REVISE APPROVED SITE PLAN TO INCLUDE 1,000 SF ADDITION ON SOUTH SIDE OF EXISTING GATHERING HALL FOR NEW LOBBY AND RESTROOMS - 5/8/2024

G.L. Castillo Architect
Thomas Wellons Consultant
Classrooms and Gathering Hall
CHURCH of the RISEN SAVIOR

ADMINISTRATIVE
DEVELOPMENT PLAN AMENDMENT
AA-45-108
FILE NO. Z-90-88
AS SHOWN
9/27/95
PLANNING DIRECTOR DATE

SITE PLAN
11 = 30'-0"
REVISED BY BOHANNAN-HUSTON INC. 07/03/95

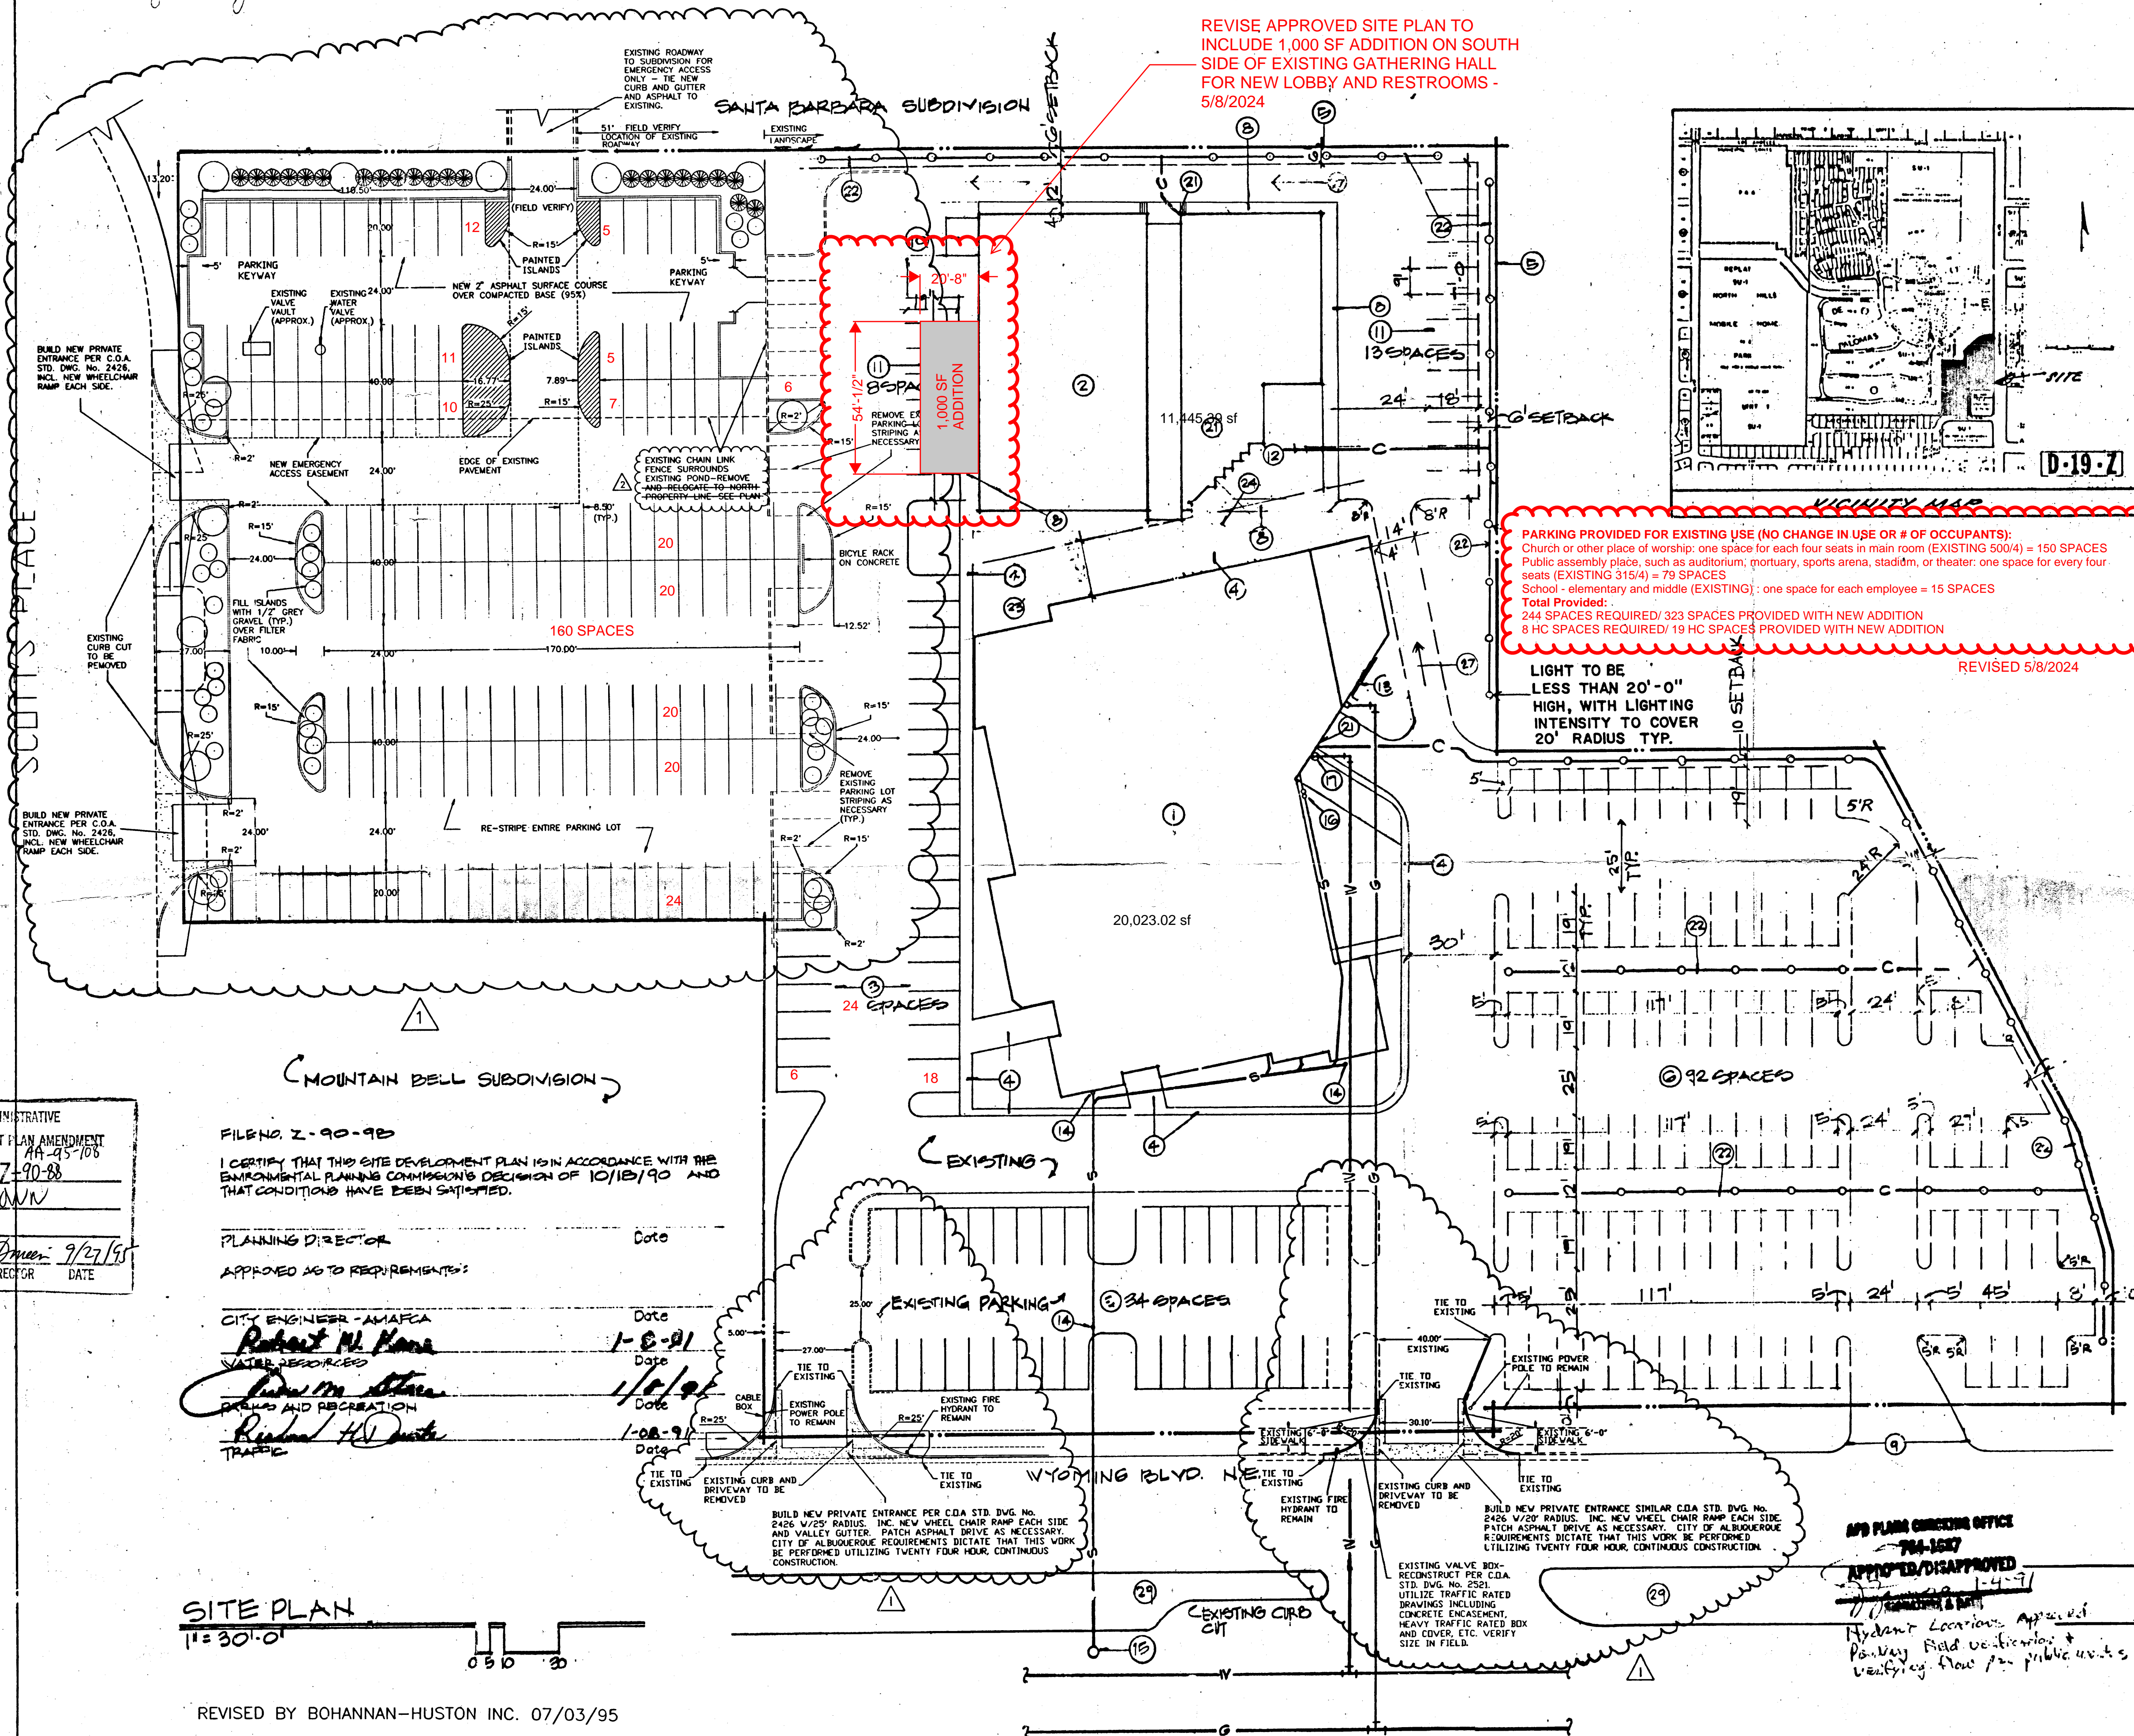
1	REVISE SOUTH PARKING LOT
2	REVISE MAIN ENTRY
3	ADD PARKING NORTHWESTERN AREA
4	ADD FENCE TO NORTH PROPERTY LINE
